Central Services Facility

PROVISIONS FOR ENCROACHMENT

RE: 3700 Gilbert, Detroit, MI
Encroachment Request for Sidewalk Replacement

REQUEST ENCROACHMENT
INTO CLAYTON ST. 60 FT. WD.
AT 3700 GILBERT ST.

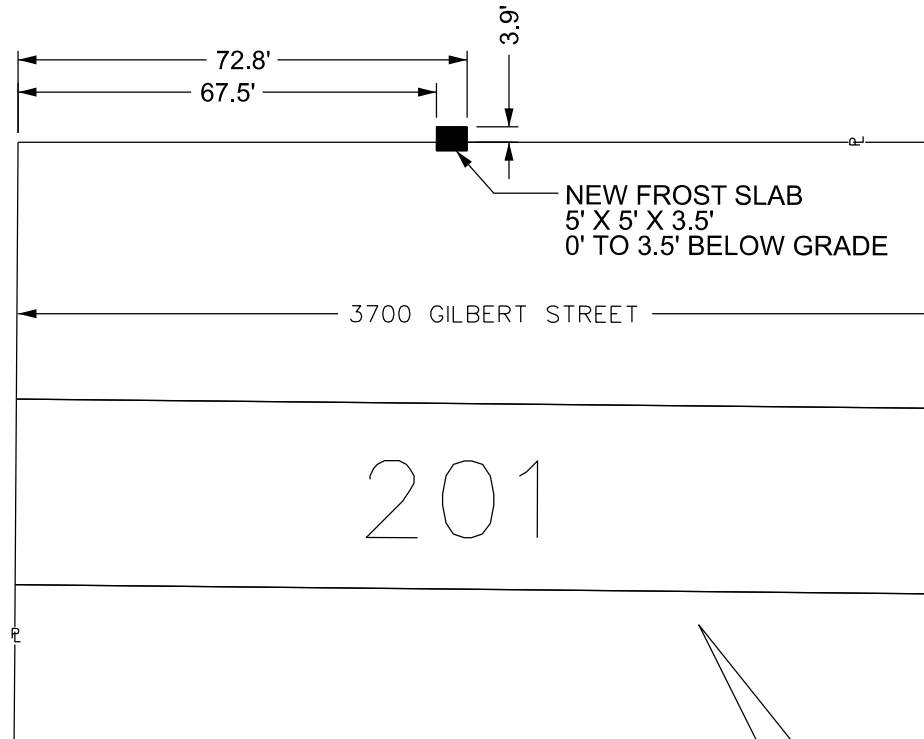
10. It is DWSD's requirement that no encroachment has a vertical clearance of less than 16 feet from the ground surface over DWSD water mains and/or sewers.

- REQUEST ENCROACHMENT
(FOR FROST SLAB, 0' TO 3.5' BELOW GRADE)
